**VALUE ENGINEERING WORKSHOP REPORT**  
**CITY OF LONGVIEW, WASHINGTON**  
**WATER SUPPLY ALTERNATIVES**

**SMITH·CULP**  
**CONSULTING**

September 4, 2007

Figure 3. Cross section at RM 0.01 surveyed in August 2003, April 2006 and December 2006 (obtained from PowerPoint presentation by Patrick O'Brien, Corps)

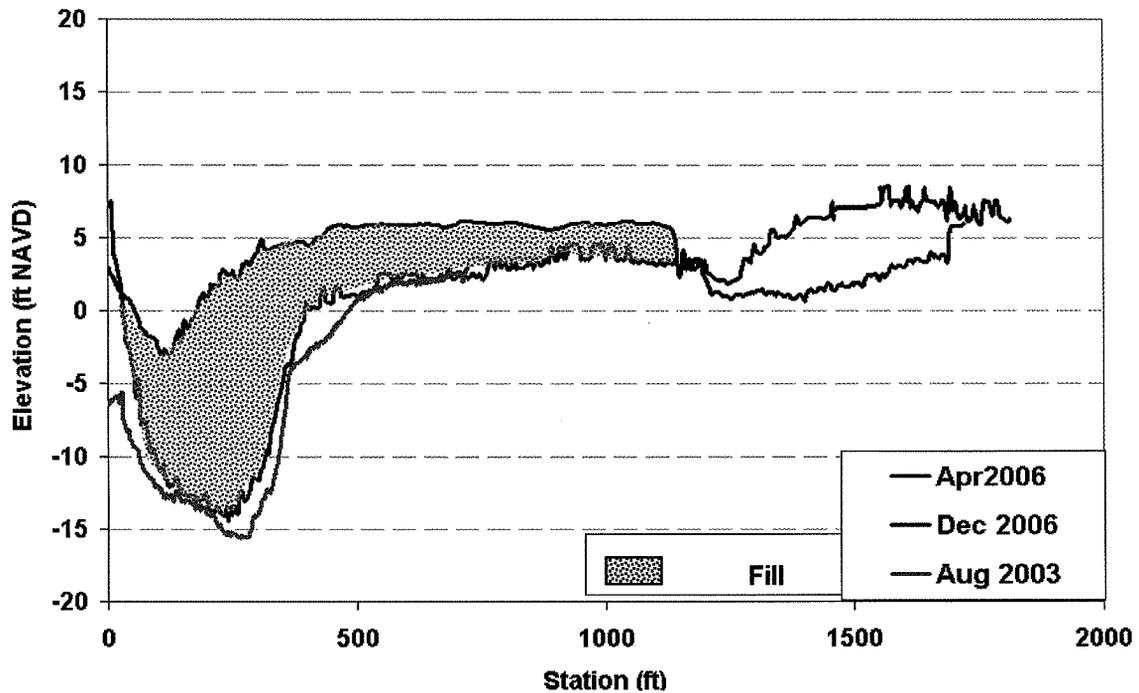
A cross section near the mouth of the river that was surveyed in August 2003, April 2006 and December 2006 has been included in several recent City and Corps presentations indicating that the late-2006 flood event caused significant additional aggradation (Figure 3). This cross section changed very little between August 2003 and April 2006, but the thalweg raised by over 10 feet and significant net aggradation occurred over much of the remainder of the cross section between the April and December 2006 surveys. The changes at this location, however, are not representative of changes farther upstream, including the vicinity of the raw water intake. The average bed elevation at River Station (RS) 5.01, just downstream from the intake, and at RS5.5, about 0.3 miles upstream from intake, for example, changed very little between the 2004 and December 2006 surveys (Figures 4 and 5). Comparison of the thalweg profiles between the 2004 and 2006 surveys also indicates that the reach between about 0.5 miles upstream from the mouth and a few miles upstream from the intake did not systematically aggrade during this time period (Figure 6).
